CONTRACT ADDENDUM NO. 1

Topeka & Shawnee County Public Library

Youth Services Renovation – Shelving Package

HTK Project No.: 2001.01-015

I100

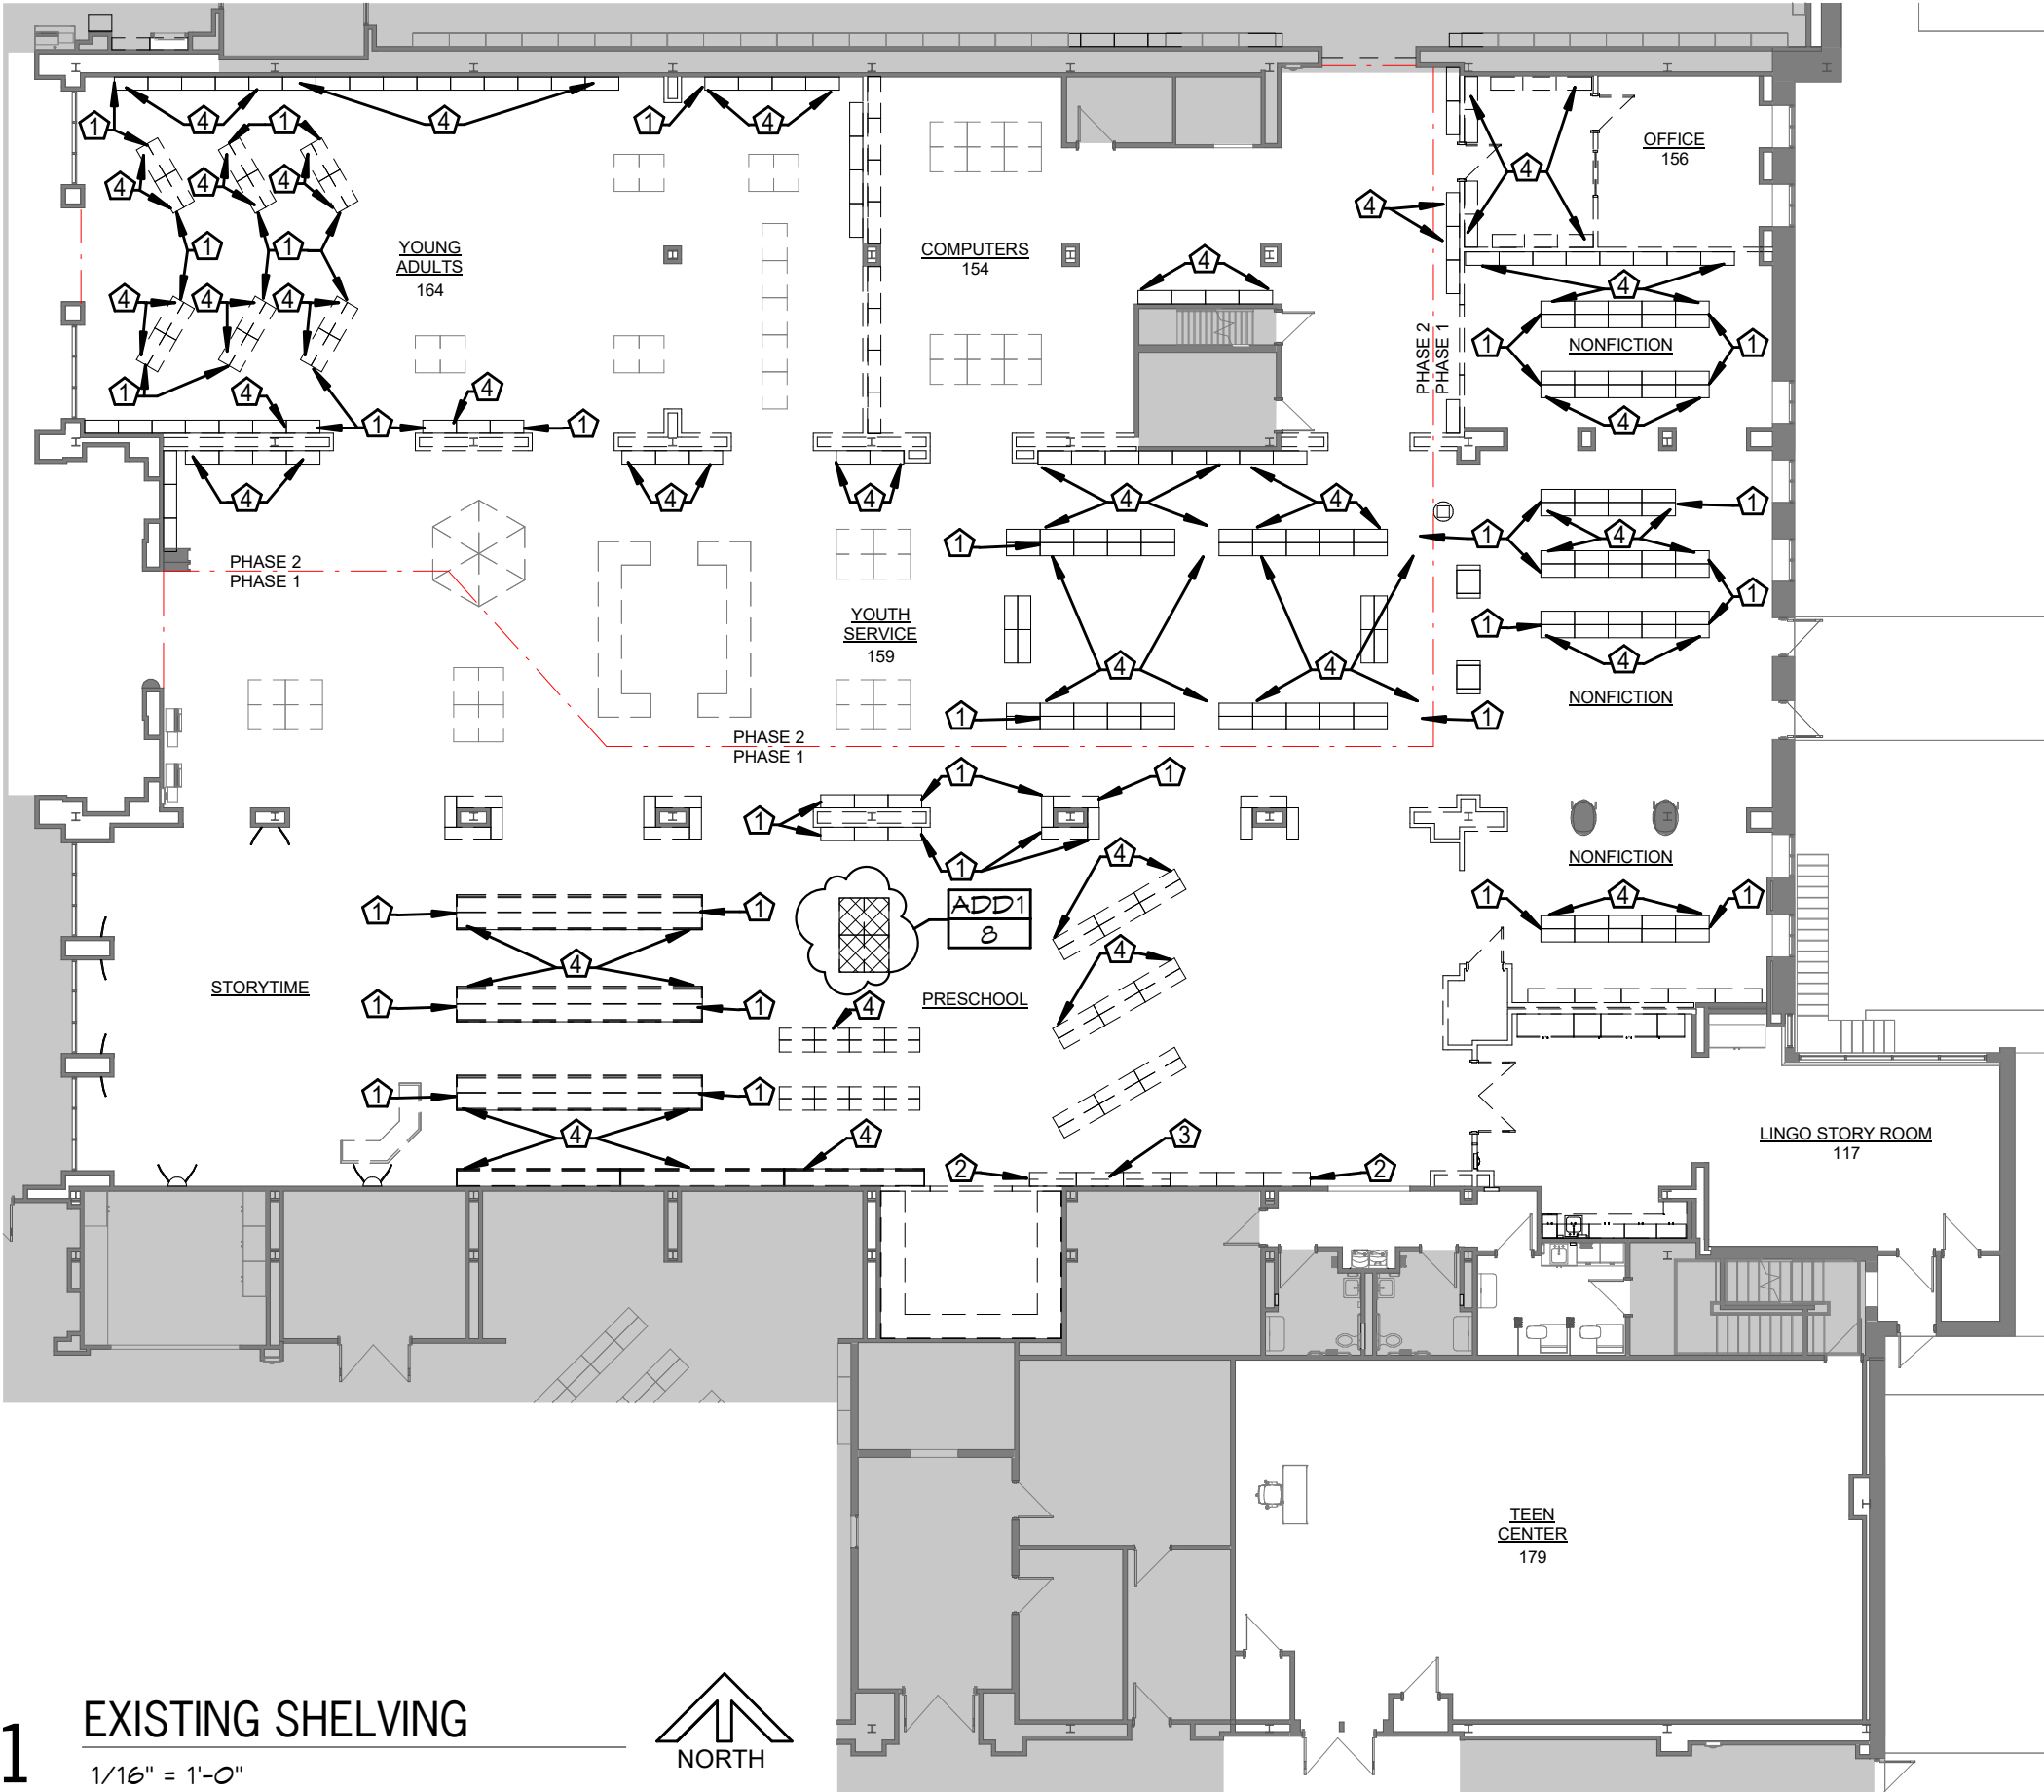
1. Revise locations of Contractor demolished shelving as indicated on Drawing Sheet.
2. Demo double door leading into Lingo Story Room 117 in lieu of salvaging door for re-installation.

I101

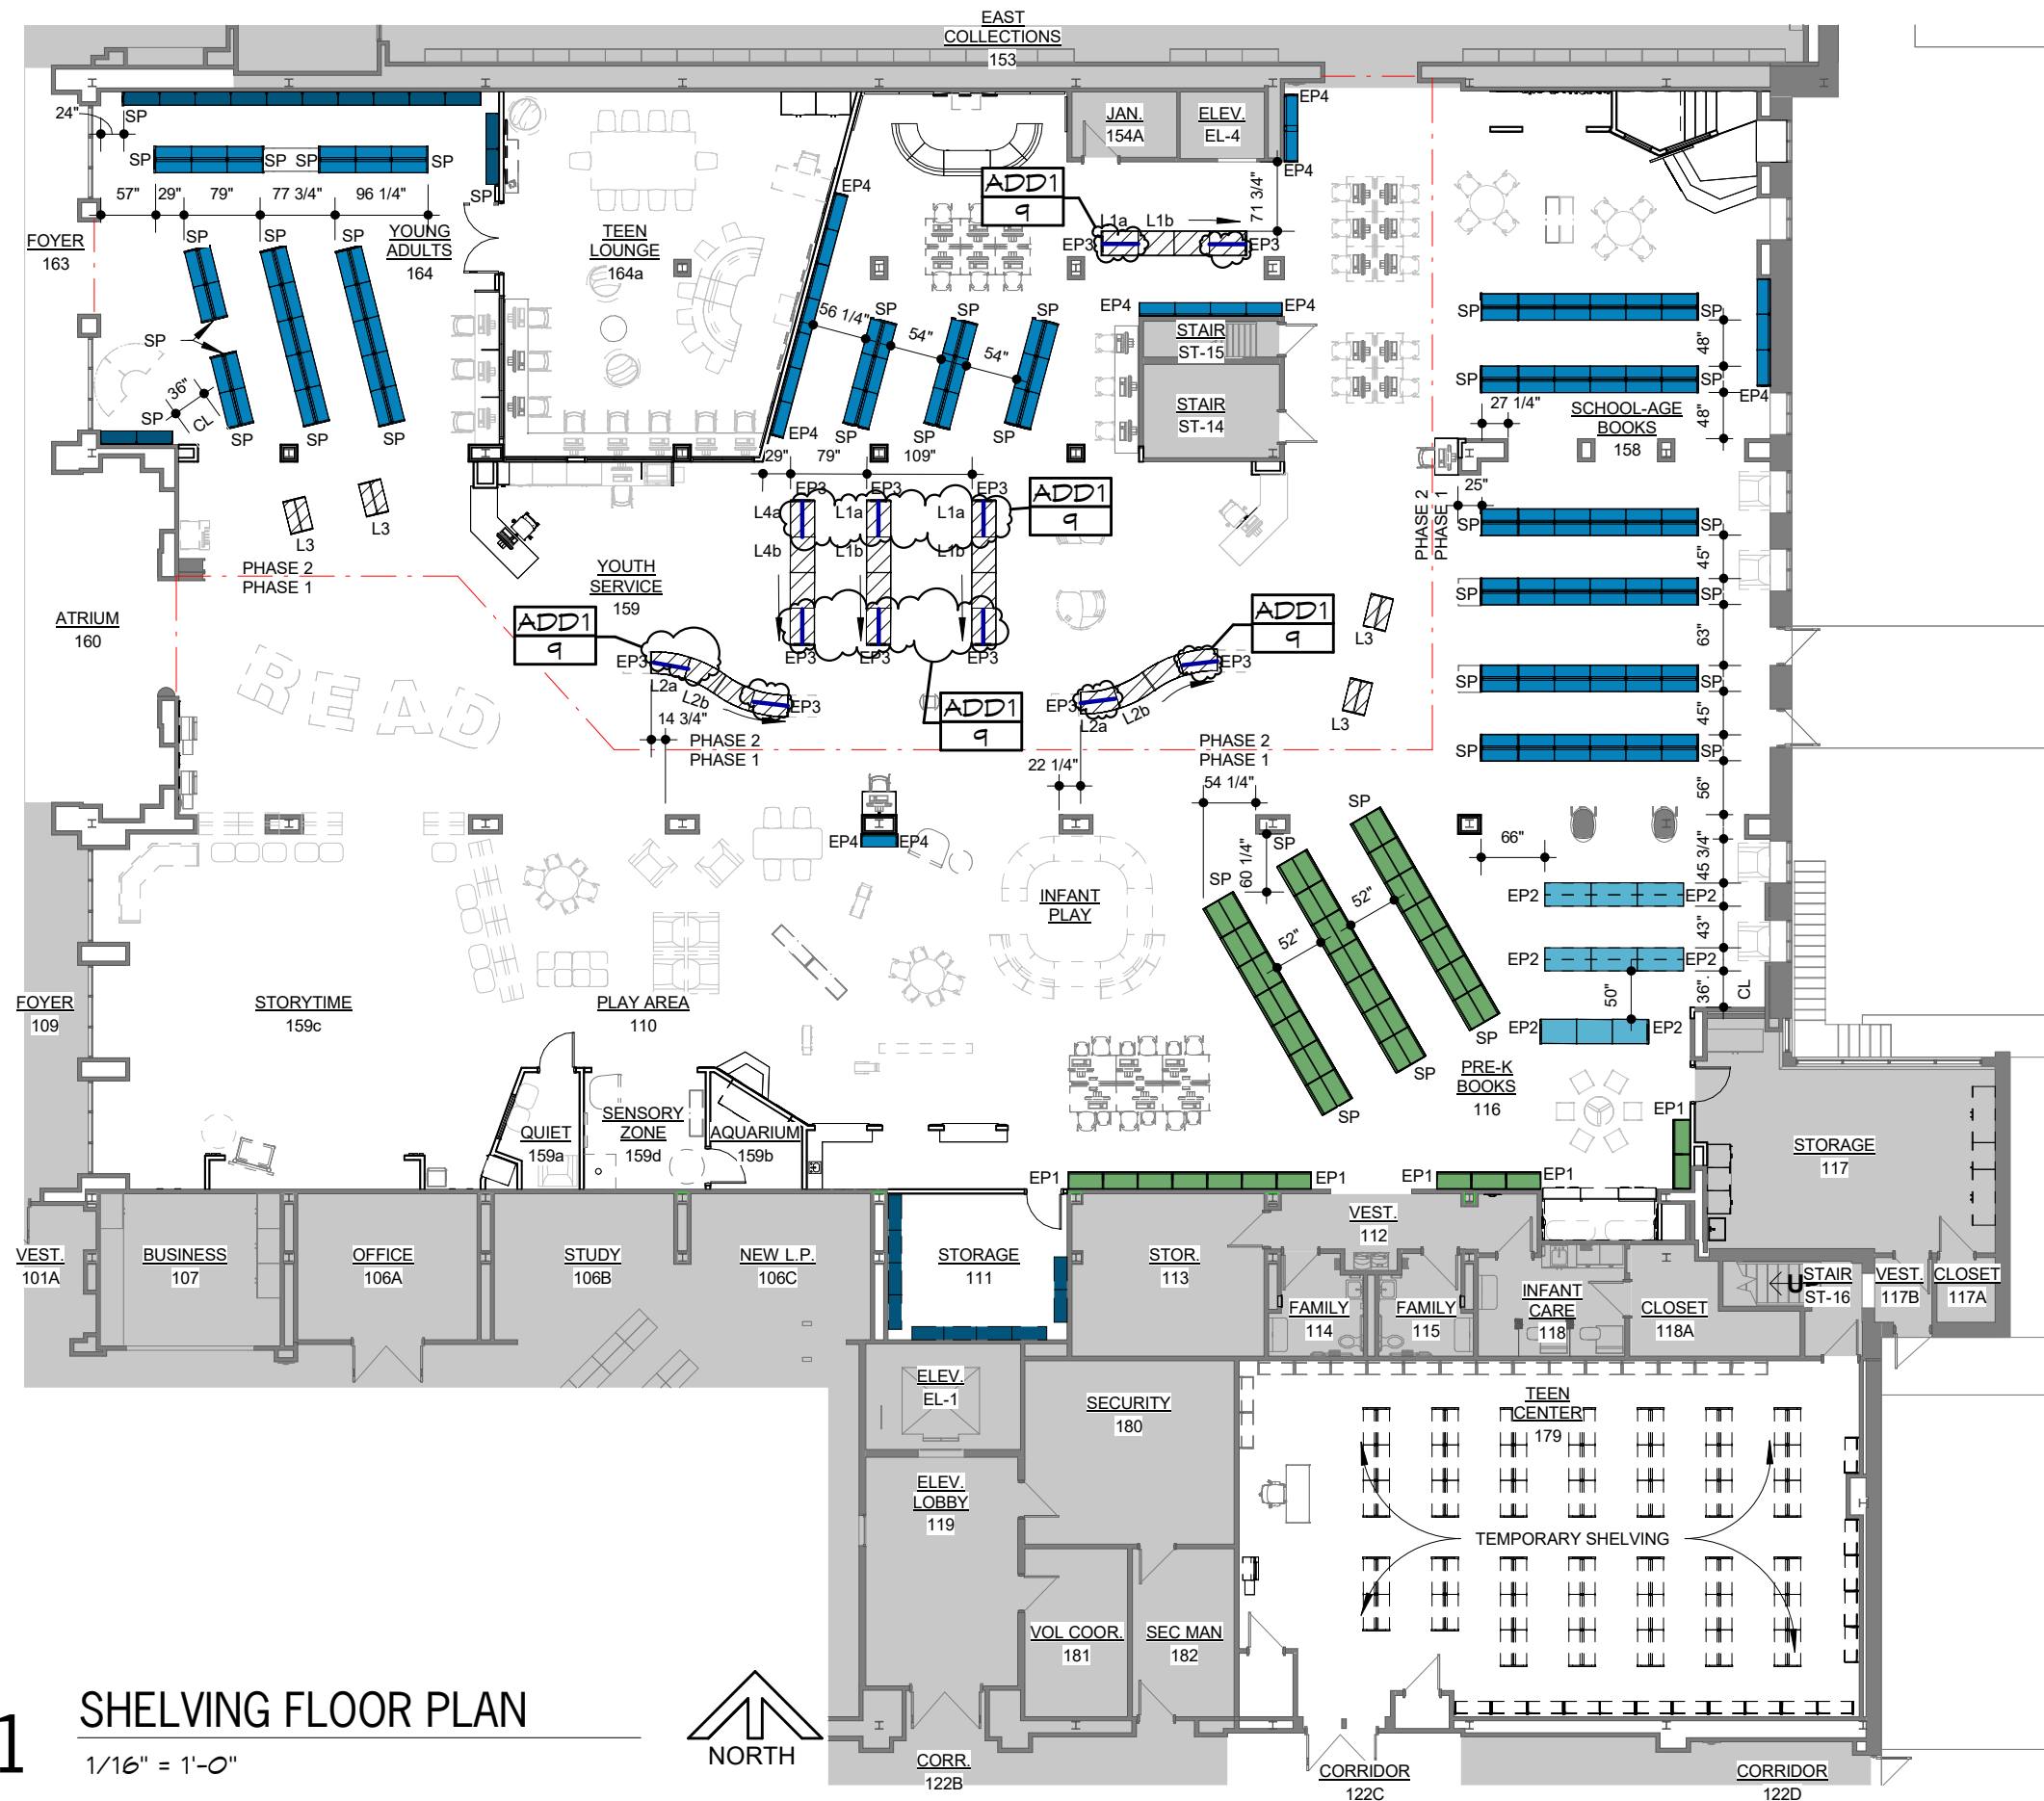
1. Clarification for Quantity: Existing integral signage shall be salvaged for re-installation at existing units. Additional Set-On Sign Holders only required at new units (not including L3 – L3 spec includes integral signage). Reference Drawing Sheet I101 for locations. There are (2) extra set-on holders included in the specification.
